Re: Docket No. 461A - CSC 461A Greenwich Substation and Line Project - Petition for Reconsideration

Response to CSC-01 Interrogatories dated 06/12/2017

STRS. 14004-14005

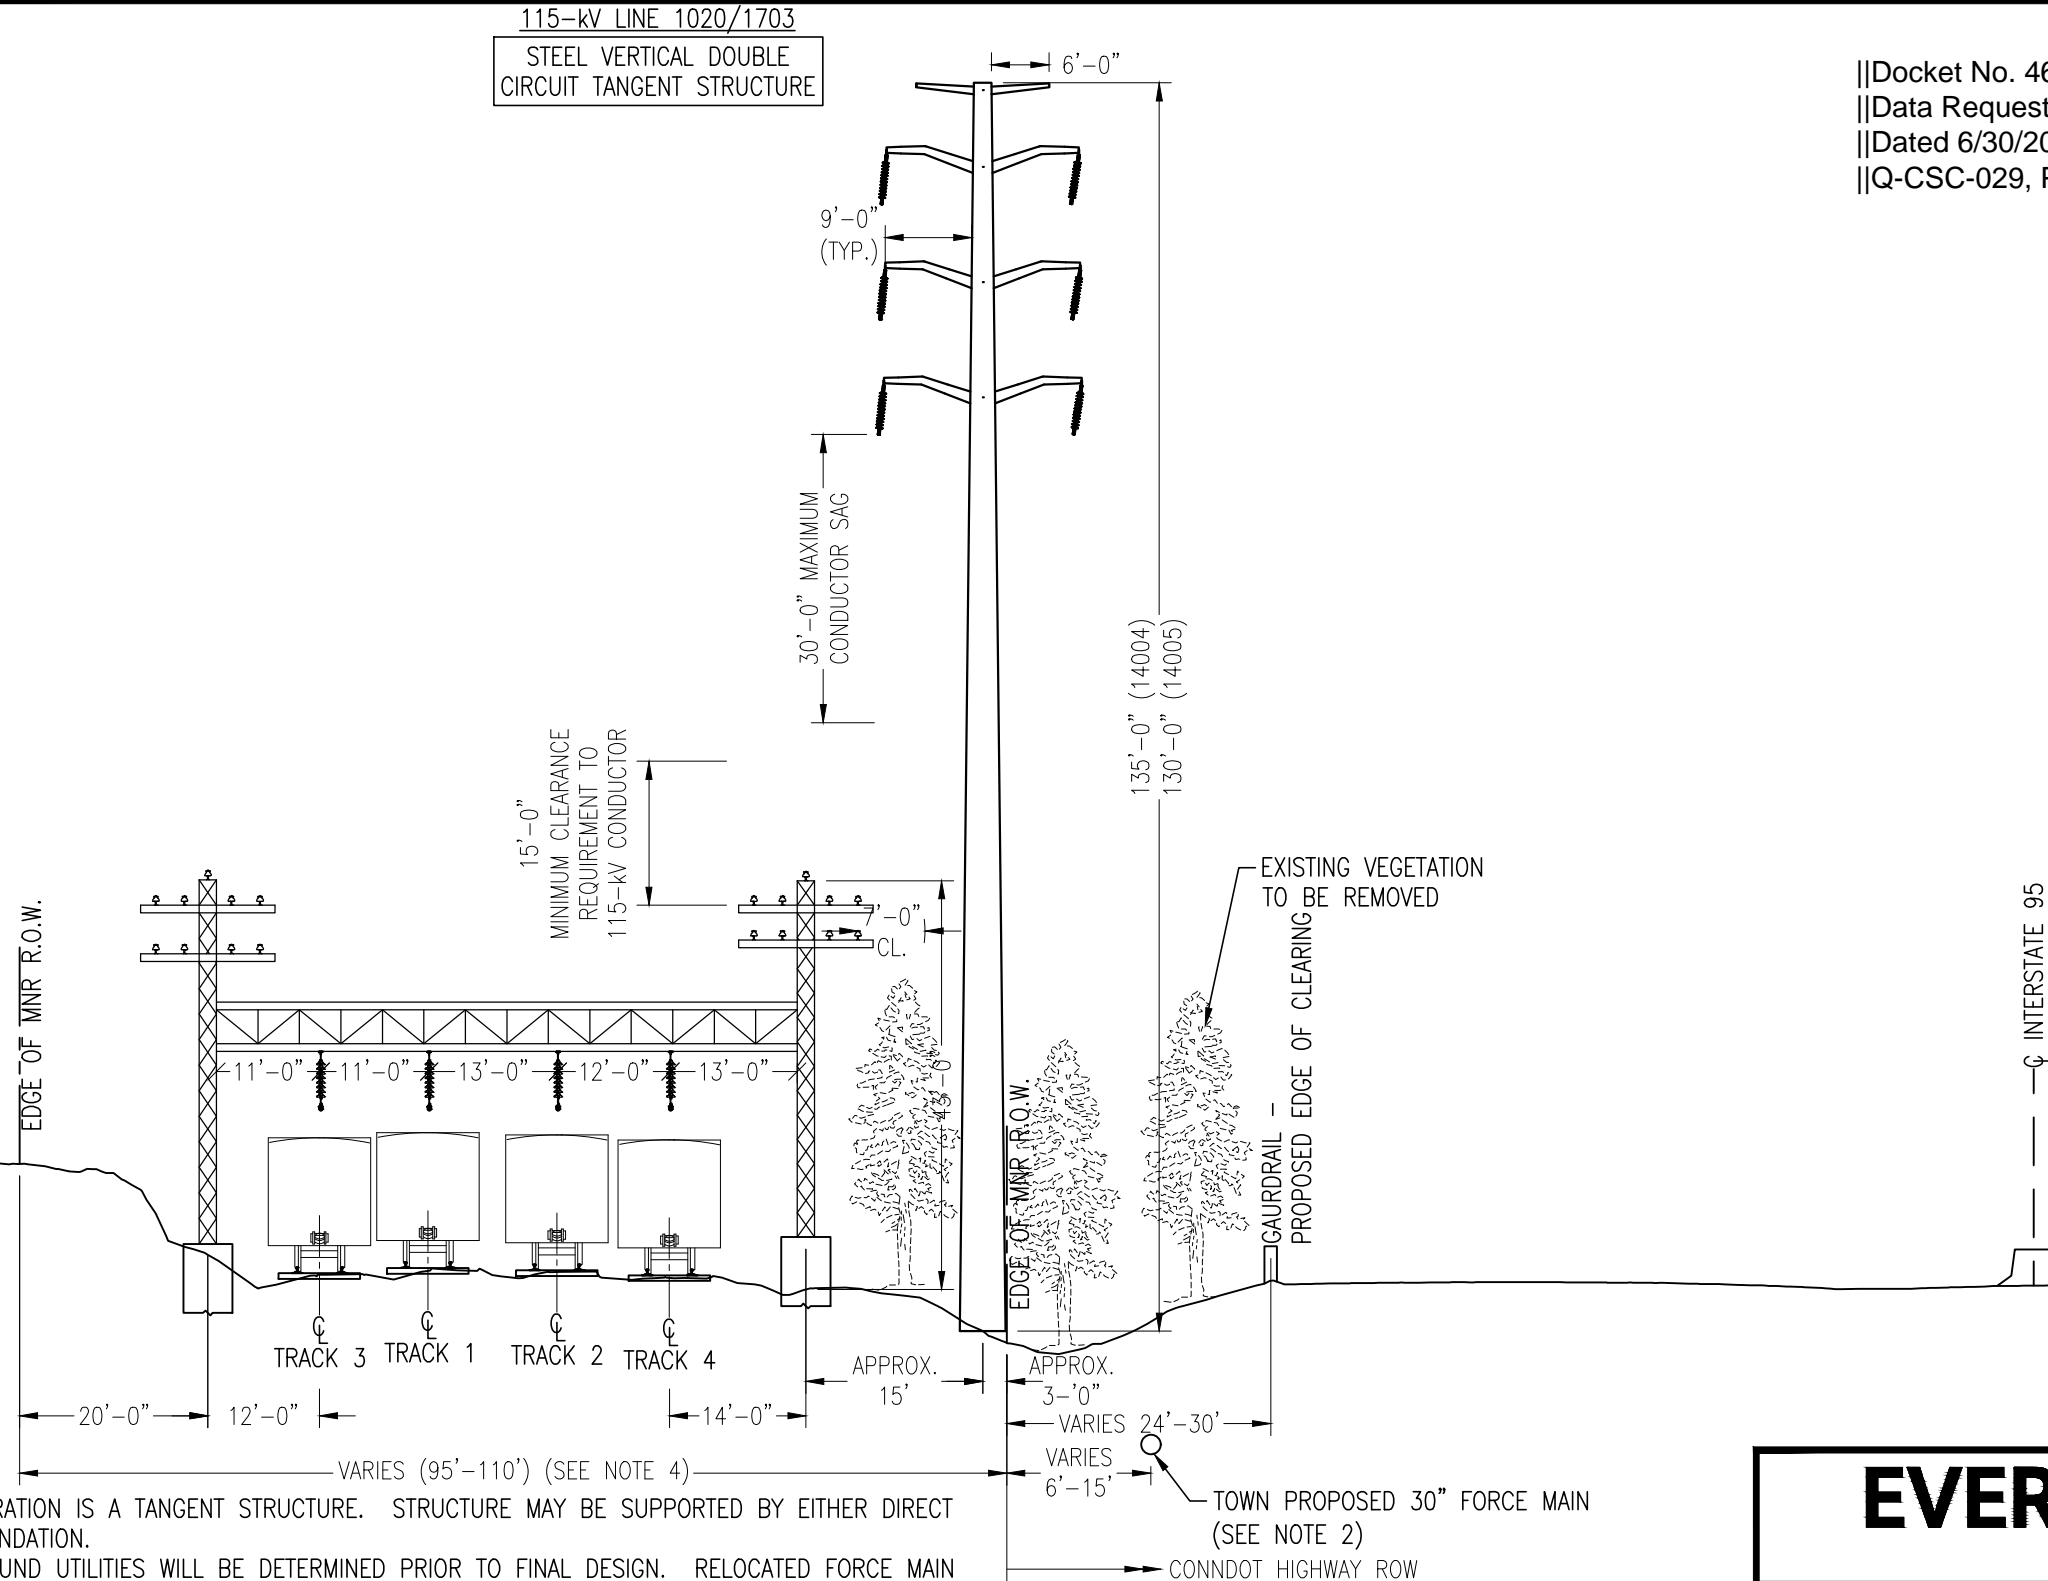
Reference Reopened Application Vol. 1, p. F-15 and Vol. 2, App. 6, sheet XSECT 4.
Structure 14004 is listed as both 130 and 135 feet tall. Please clarify.

The preliminary height of structure 14004 is 135 feet. Volume 2, Appendix 7, sheet XSECT 4 incorrectly inversed the height of structures 14004 and 14005; therefore the height of structure 14005 is 130 feet rather than 135 feet. Updated cross sections reflecting this modification are attached.

LOOKING
EAST
CORRIDOR LENGTH
0.29 MILE
STR. 14006

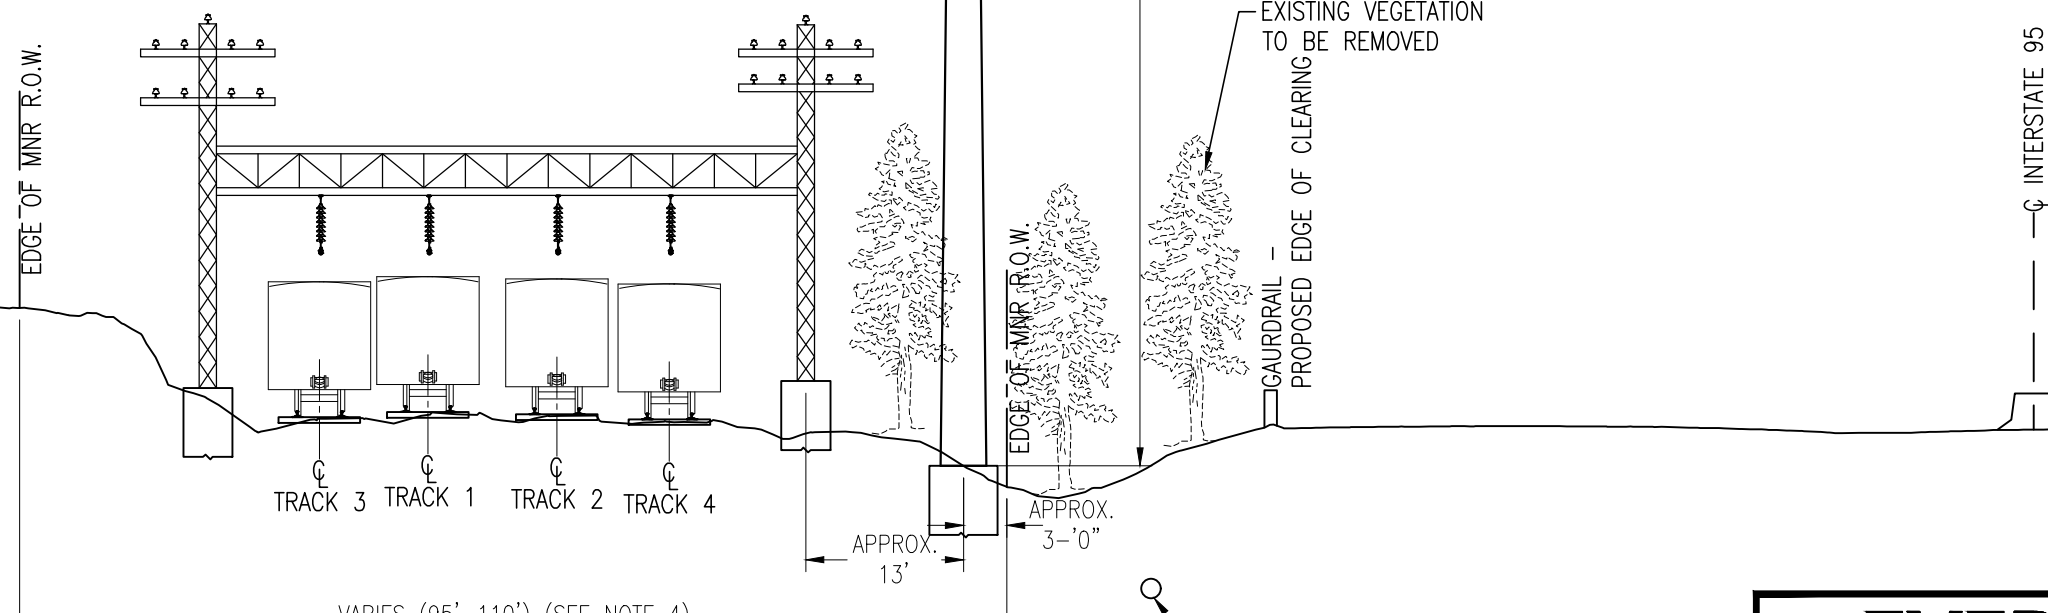
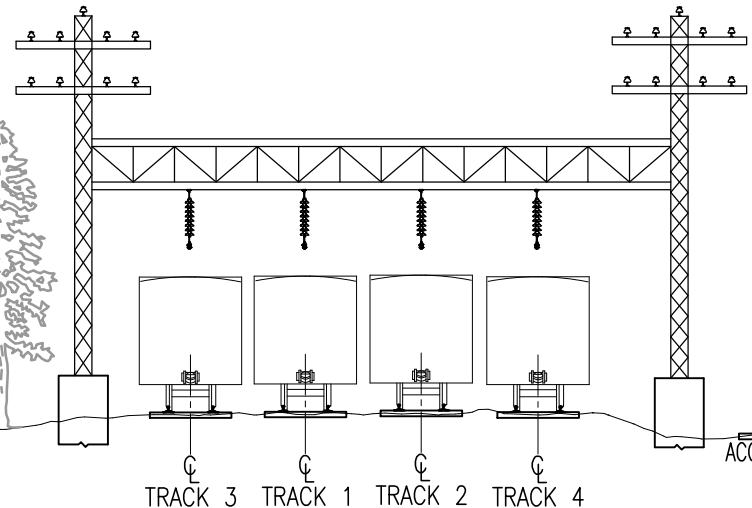
Provide a cross section sheet from Force Main Variation structure 14006 shown on Reopened Application Vol. 1 Figure F-3. What type of foundation would be required for this structure? Provide preliminary details as to the size and depth of this foundation.

1. DEPICTED STRUCTURE CONFIGURATION IS A TANGENT STRUCTURE. STRUCTURE MAY BE SUPPORTED BY EITHER DIRECT EMBED OR DRILLED SHAFT FOUNDATION.
2. EXACT LOCATION OF UNDERGROUND UTILITIES WILL BE DETERMINED PRIOR TO FINAL DESIGN. RELOCATED FORCE MAIN WITHIN TRANSMISSION LINE CORRIDOR FOR PORTION OF ROUTE.
3. STRUCTURE HEIGHTS CONTROLLED BY MINIMUM CLEARANCE REQUIREMENT TO RAILROAD CATENARY WIRES.
4. MNR ROW WIDTH VARIES ON SOUTH SIDE OF TRACKS DUE TO CONNDOT HIGHWAY ROW.
